From: [Phaedra Hise](#)
To: [Oliver, Alyson E. - PDR](#)
Subject: public comment for UDC 2025-19 Holly Street Playground
Date: Tuesday, July 15, 2025 6:22:06 AM

Thanks for the opportunity to comment on the Holly St Playground Plan.

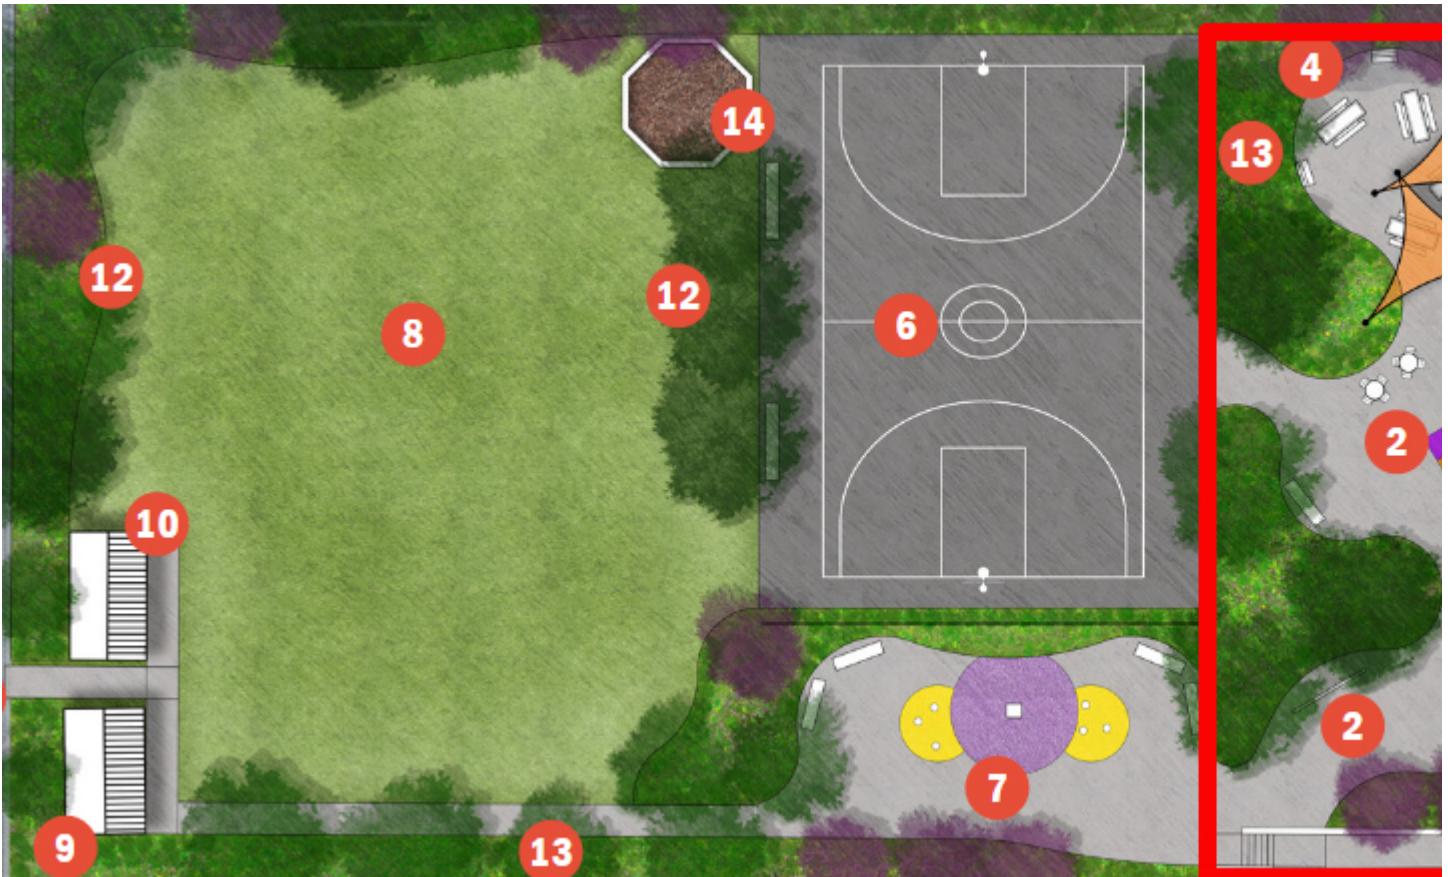
- * **Greatly reduce the proposed new huge area of impermeable hardscape concrete in the "Pedestrian Plaza" of the playground**
- * **Define "Skateboard Nook" as a couple small features to exclude large skateboard features, like half-pipes and quarter-pipes**
- * **Add shading for tot-lot feature so that it can be used in hot weather**
- * **Replace chain-link fencing on south and east sides of playground with iron fencing**

PLEASE do not allow almost a quarter of our small playground to be covered in new concrete! This would greatly increase the impermeable surface area (as shown outlined in red, below):

No one knows what a **"Skateboard Nook"** is. Please define a "Skateboard Nook" shown in the plan as "a couple of small features, excluding half-pipes and quarter-pipes." It would be very unsafe to have large skateboard features, such as half-pipes or quarter-pipes, beside the tot-lot.

Many requests for **shade over the tot-lot equipment** were made and should be included in the final plan. On these hot summer days, the kids cannot use the slides and other tot-lot features due to the sun baking the play equipment.

Please include mention of **replacing the chainlink fencing** in the plan. (We have requested that the solid iron fencing that is being removed from Mayo Island be repurposed at Holly Street Playground.)
